LANEY

TITLE	VC30-212 VC30-210 , VC30-112 PCB 9072_3 MODIFIED PART No

DRAWING No.	2401

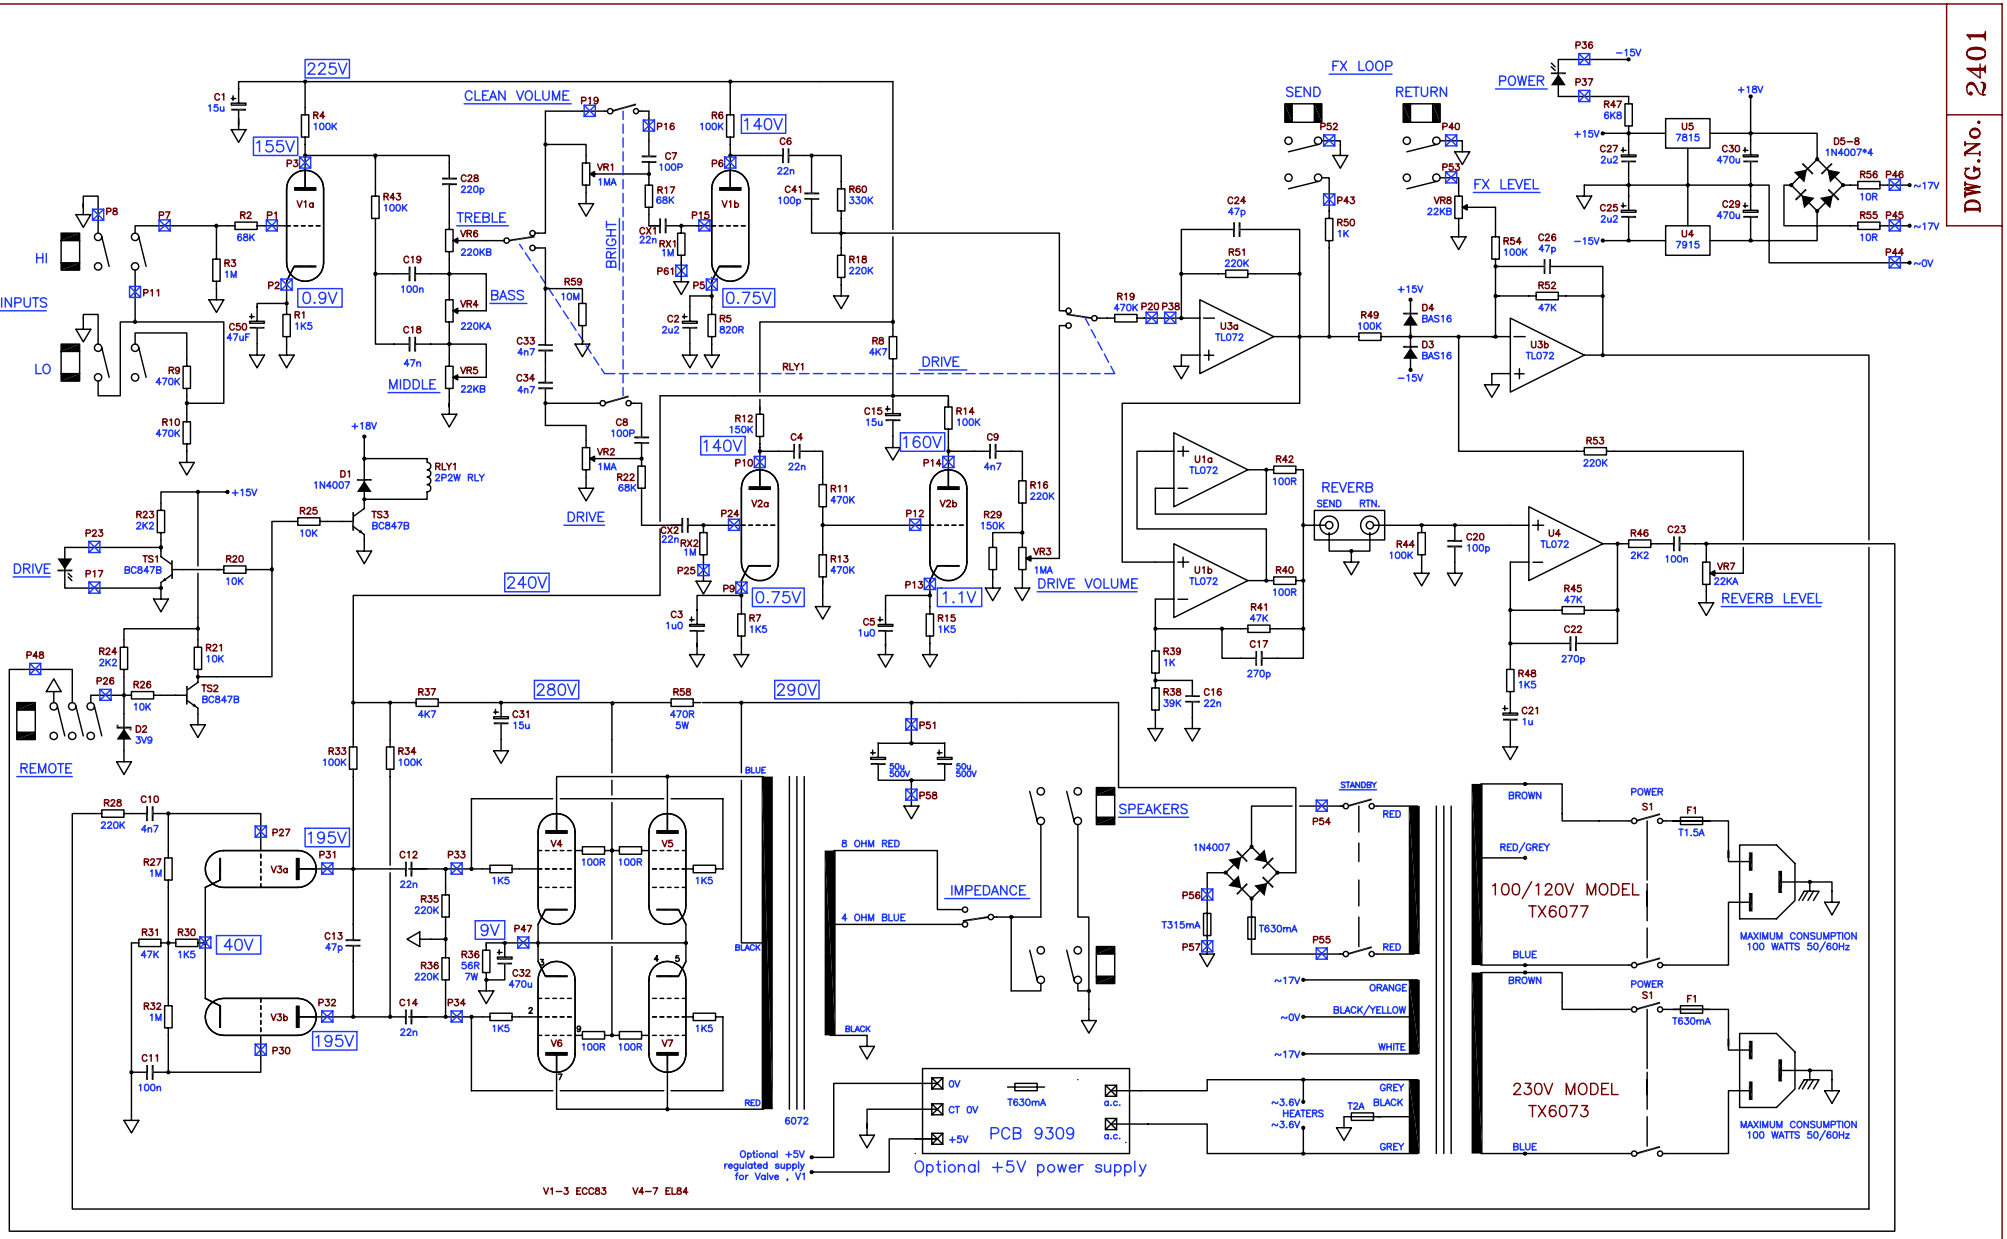
UE	DESCRIPTION	APPD.	DATE
3	Added CX1,CX2,RX1,RX2. Changed C50 from 1u to 47uF	RST	21/04/04
3	Option added for regulated +5V Supply R.J.F 6073 to 230V primary + Heater V increased	SL	8/10/98
	Ht fuse changed to T315mA from T500mA SEE CHANGE NOTE 173	S.L.	28/9/98
